REQUESTS FOR INFORMATION NOT ADDRESSED IN THIS CCO REMAIN IN FORCE					
3	08/29/08	TOWER ANCHORAGE BASE PLATE GROUT	JD	MN	36S1
2	02/28/07	TOWER BASE PLATE	JD	MN	36
1	06/23/06	DELETE GAP TABLES	MN	NV	21
MARK	DATE	DESCRIPTIONS	BY	CH'D	CCO#
REVISIONS

CONTRACT CHANGE ORDER NO. ____
SHEET ___ OF ___

SAN FRANCISCO OAKLAND BAY BRIDGE
EAST SPAN SEISMIC SAFETY PROJECT
SELF-ANCHORED SUSPENSION BRIDGE (SUPERSTRUCTURE & TOWER)

TOWER ANCHORAGE DETAILS NO. 6

TOWER ANCHORAGE DETAILS NO. 6A

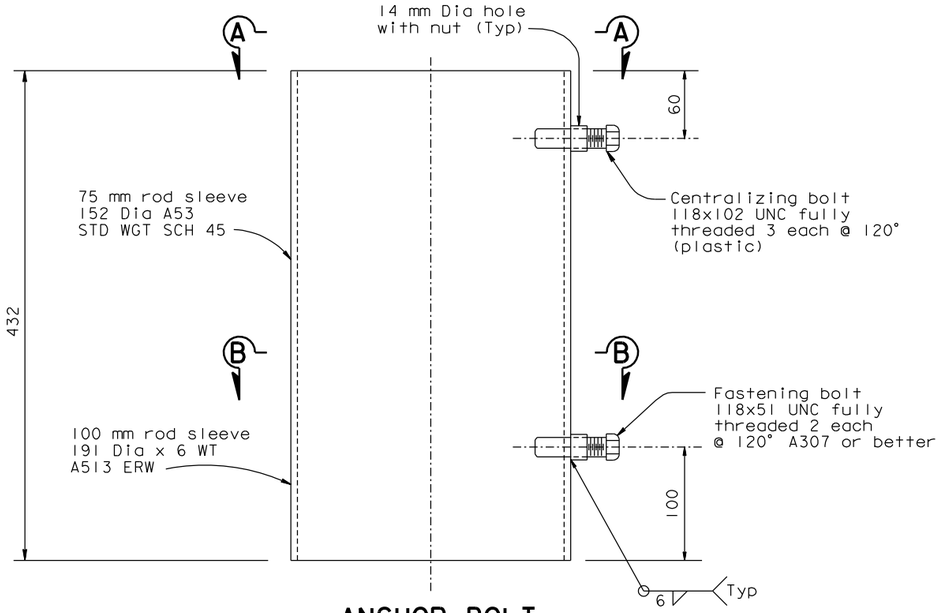
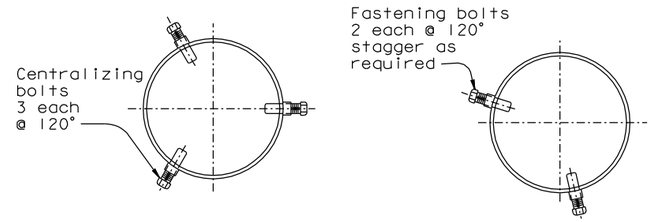
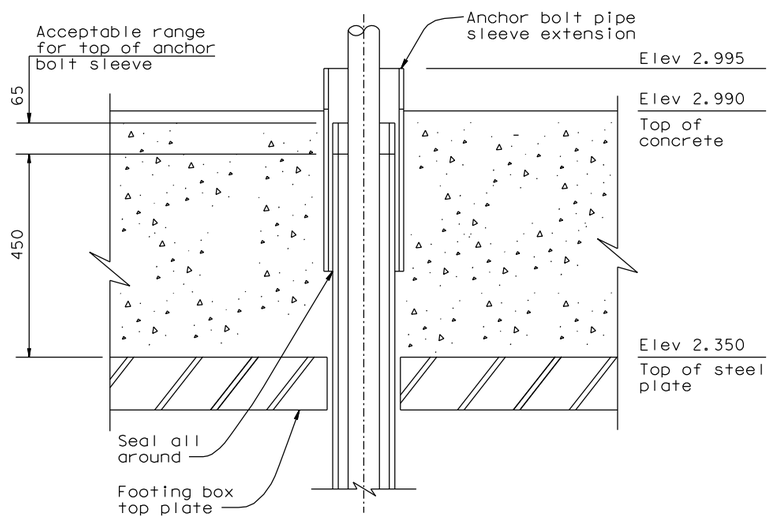
MARK	DATE	DESCRIPTIONS	BY	CH'D	CCO#
0	08/29/08	TOWER ANCHORAGE BASE PLATE GROUT	JD	MN	36S1

1. Pipe sleeve extensions are galvanized per ASTM A123.

TOWER ANCHORAGE DETAILS NO. 7

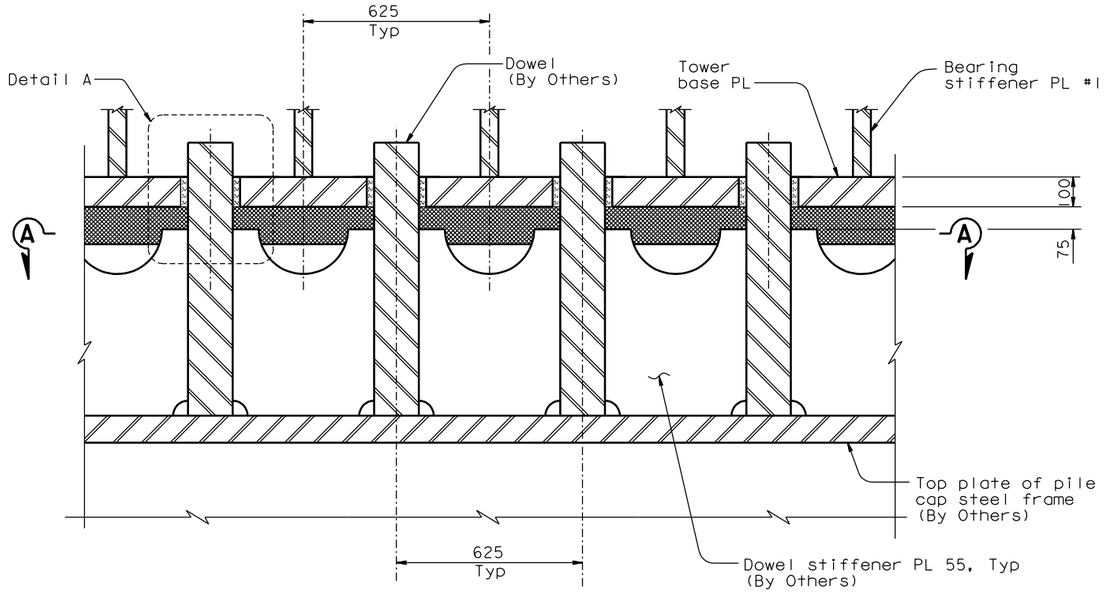
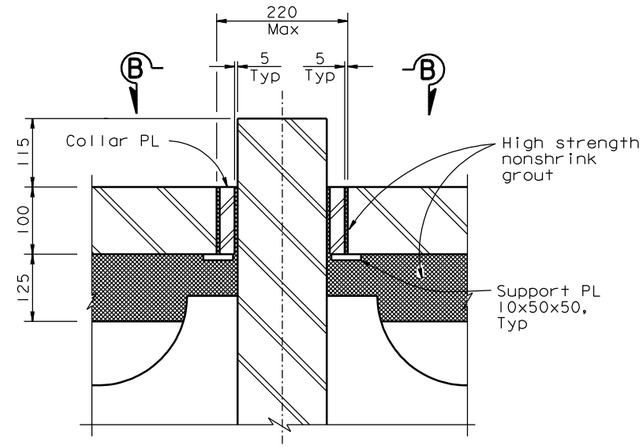
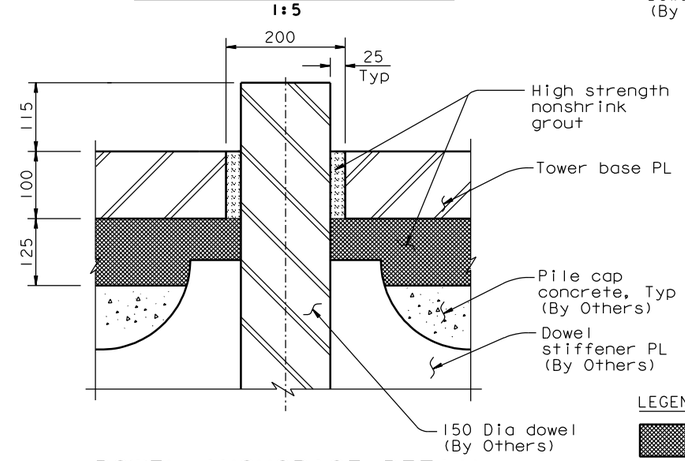
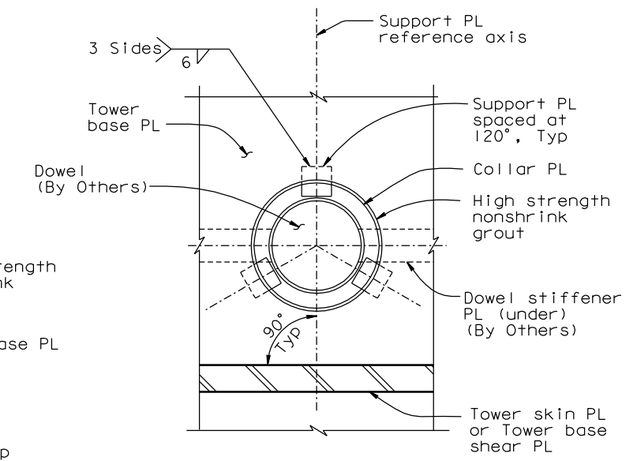
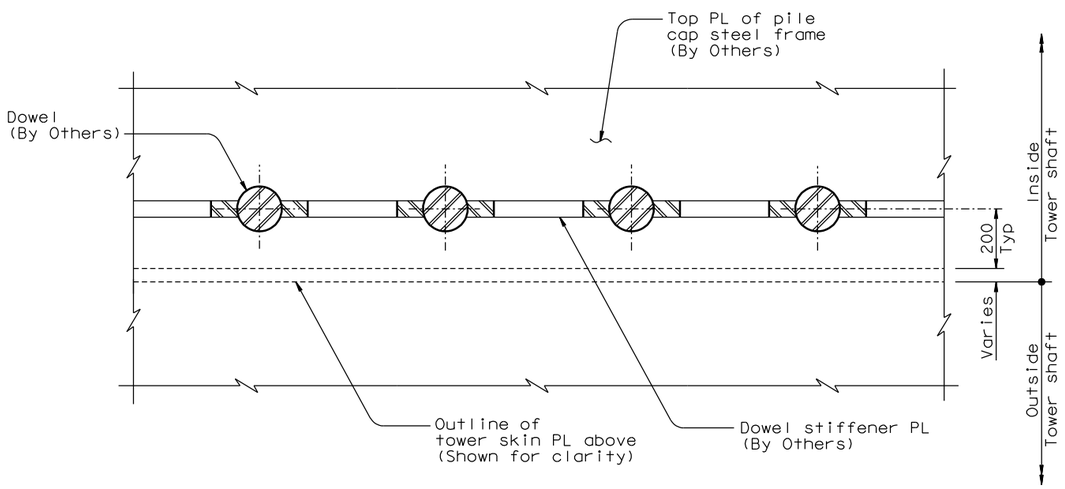
MARK	DATE	DESCRIPTIONS	BY	CH'D	CCO#
3	08/29/08	TOWER ANCHORAGE BASE PLATE GROUT	JD	MN	36S1
2	04/03/07	TOWER BASE PLATE	JD	MN	36
1	02/28/07	TOWER BASE PLATE	JD	MN	36

1. For dowel layout, see "Tower Anchorage Details No. 3" sheet.
2. Oversize hole in tower base PL is an acceptable alternative to accomodate tolerance requirements for the erection of the tower base plate. Collar plates shall be A709M Gr. 345 and shall be fabricated based on field measurements and then installed.
3. The Contractor shall recommend an epoxy grout based on manufacturer's recommendations, subject to review and approval of the Engineer.
4. The Contractor may submit alternate dowel anchorage details to suit his erection means and methods, subject to review and approval of the Engineer.

TOWER ANCHORAGE DETAILS NO. 8

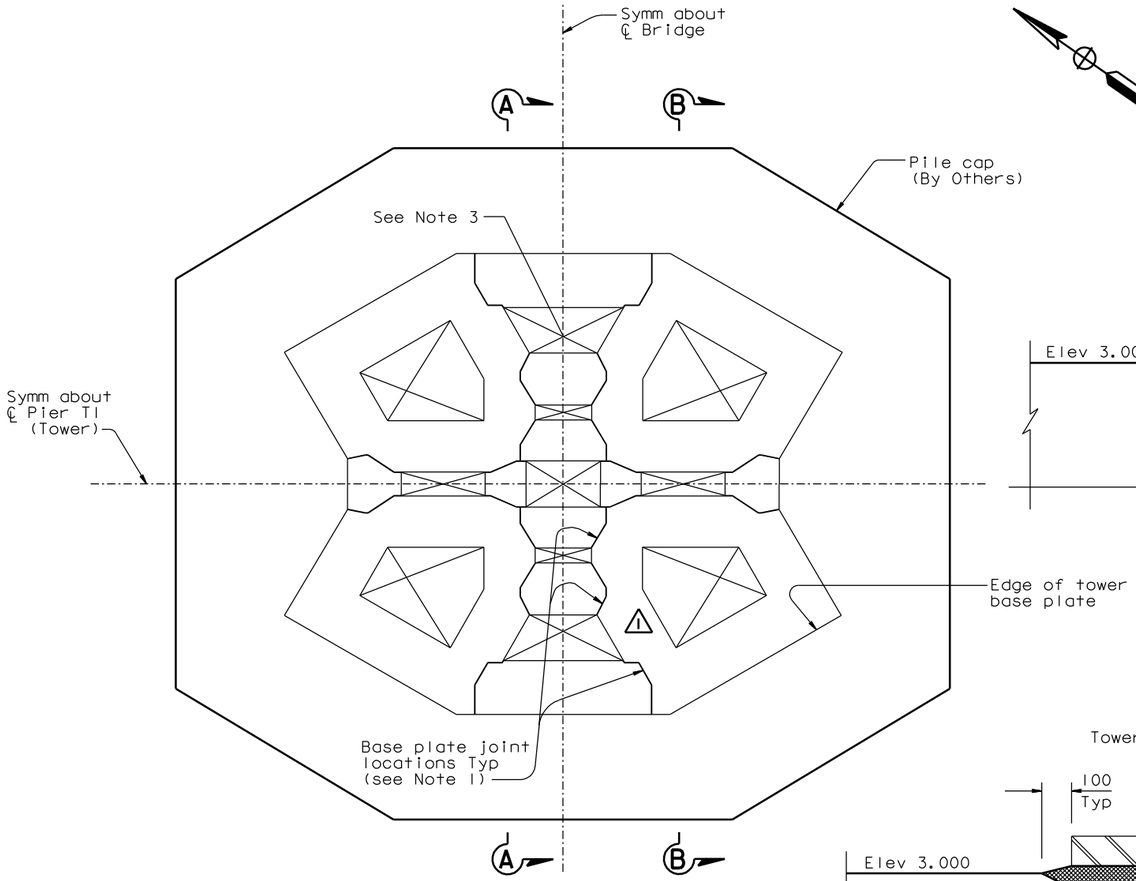
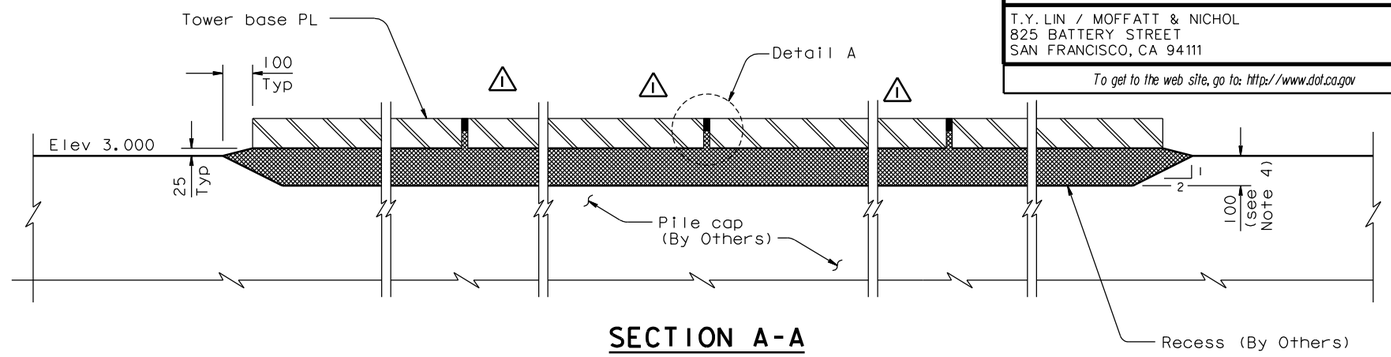
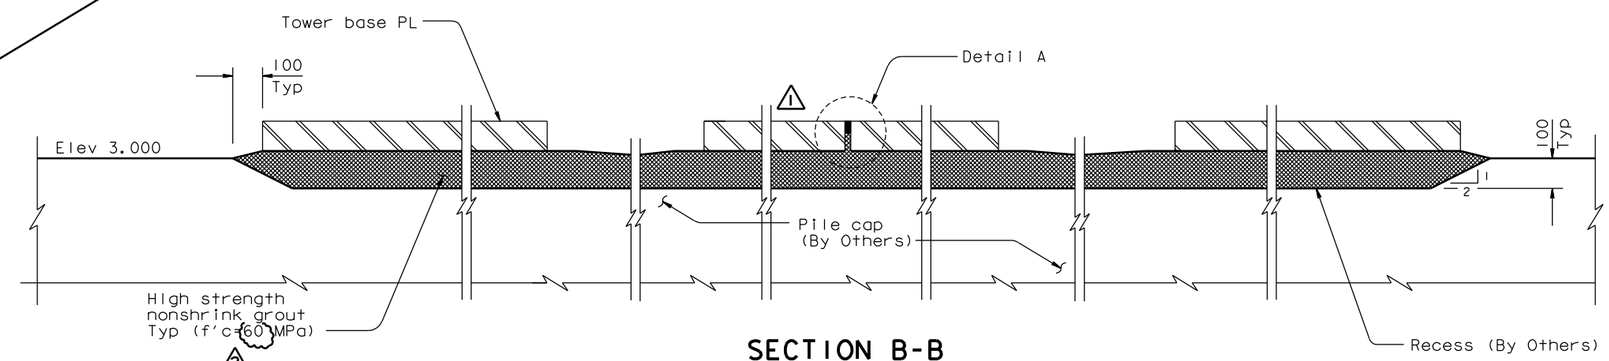
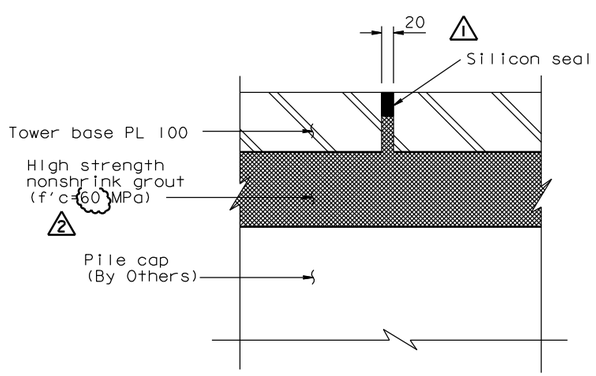
MARK	DATE	DESCRIPTIONS	BY	CH'D	CCO#
2	02/12/08	TOWER ANCHORAGE BASE PLATE GROUT	AS	MN	36S1
1	02/28/07	TOWER BASE PLATE	AS	MN	36

1. For layout of tower base plate joint, see "Tower Anchorage Details No.2" sheet. The Contractor may provide an alternative layout subject to the review and approval of the Engineer.
2. Base plates under each tower shaft and each shear plate shall be single plates or shall be built up from pieces by CJP welds done in the shop.
3. For tower drainage, see "Tower Drainage Details" sheets.
4. The Contractor may vary the depth of grout in order to achieve specified tolerances, provided there is positive flow towards the drains and the elevation of the top of the tower base plate is higher than the top of the drain.

TOWER SKIRT DETAILS NO. 4

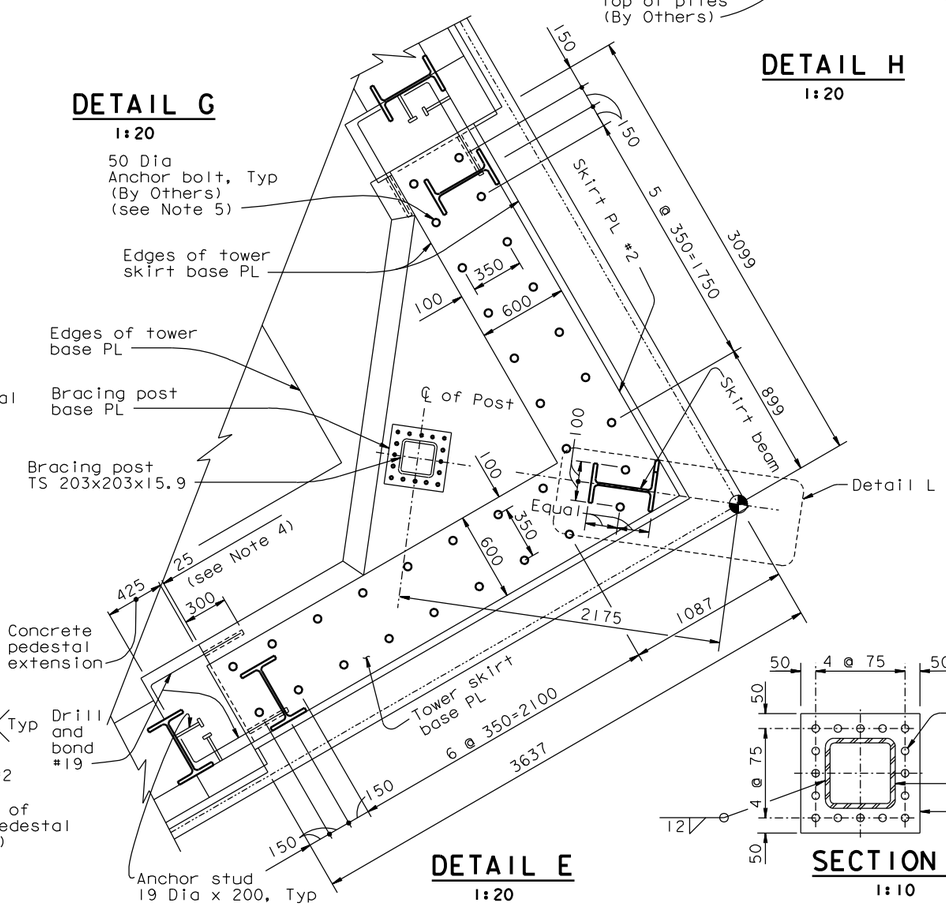
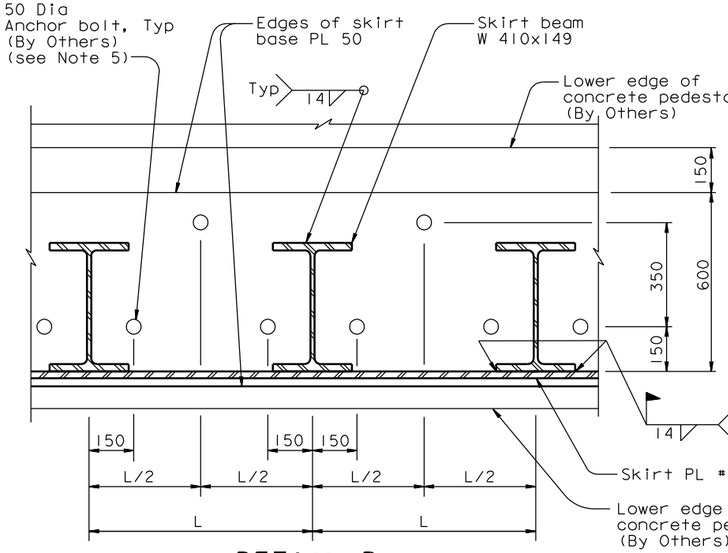
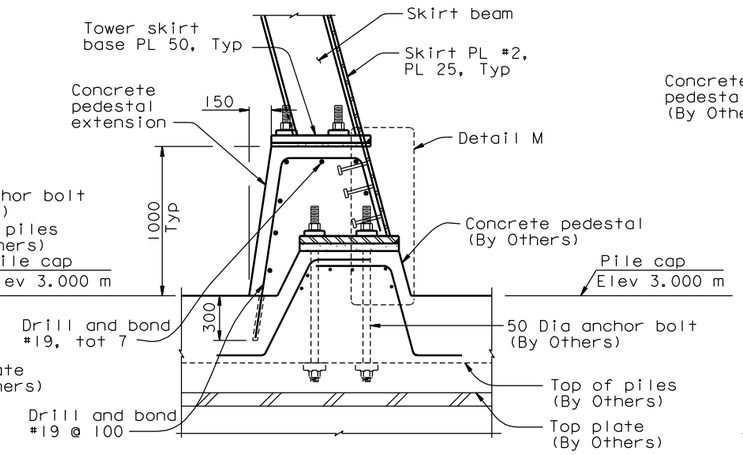
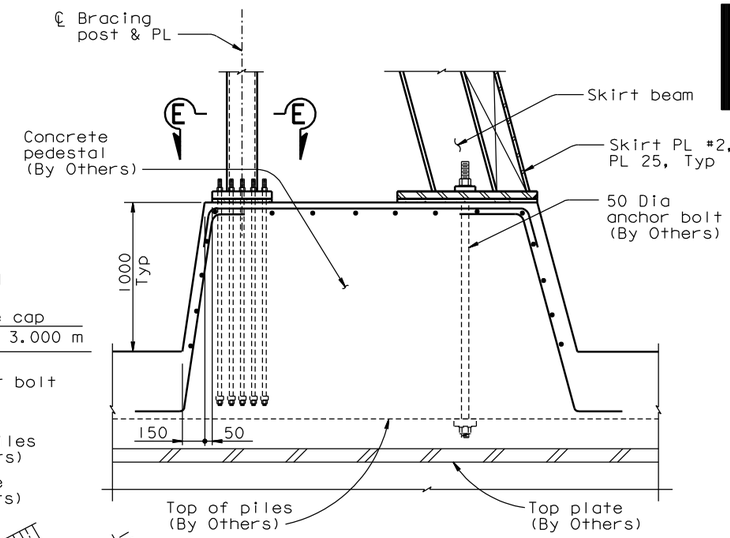
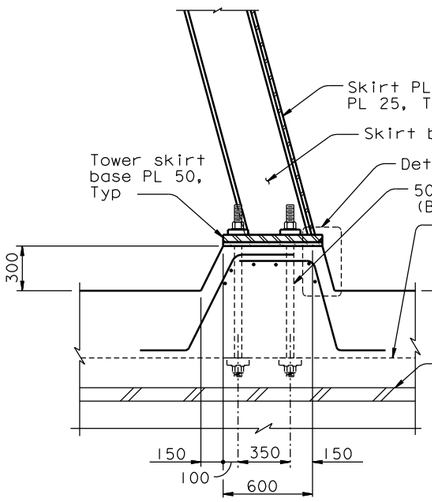
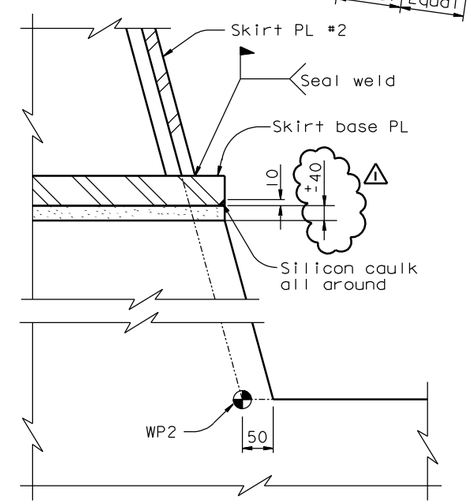
MARK	DATE	DESCRIPTIONS	BY	CH'D	CCO#
1	02/12/08	TOWER ANCHORAGE BASE PLATE GROUT	MN	NV	36S1

1. For tower anchorage details, see "Tower Anchorage Details" sheets.
2. Reinforcement is for information only, and by Others.
3. Tower skirt anchor bolts shall be pretensioned to 50% of their ultimate tensile strength. Tower skirt anchor bolts are A354 Gr. BC.
4. Remove existing cover concrete.
5. The Contractor shall field verify the locations of all anchor bolts before drilling holes in the skirt base plate.
